In the Matter of PacifiCorp's 2011 Integrated
Resource Plan

Docket No. 11-2035-01

Comments of Utah Clean Energy

Figure 9.1 – Annual and Cumulative Renewable Capacity Additions, 2003-2030

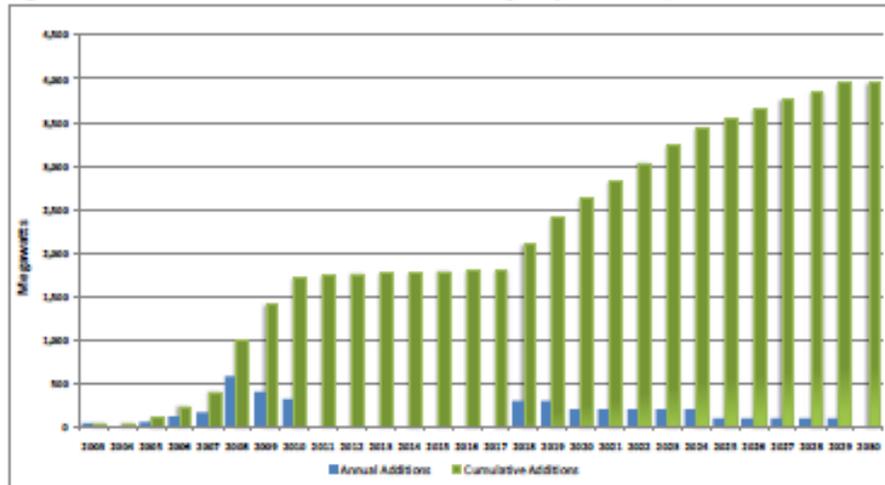
Figure 9.1²⁸ graphs the annual and cumulative renewable capacity additions between 2003 and 2030:

It is interesting to compare this graph with the coal plant investment graph found in *PacificCorp's Emissions Reduction Plan*.²⁹ There is no wind acquisition during the most costly

coal retrofitting years; wind acquisition picks up only after the company has completed most of the retrofits.

Nevertheless, the timing of wind acquisitions is relevant both to cost and risk mitigation. The Company should take care not to miss opportunities to take advantage of federal incentives, prime locations, available transmission, and low turbine prices, and should revise its action plan to add wind sooner in the planning period.
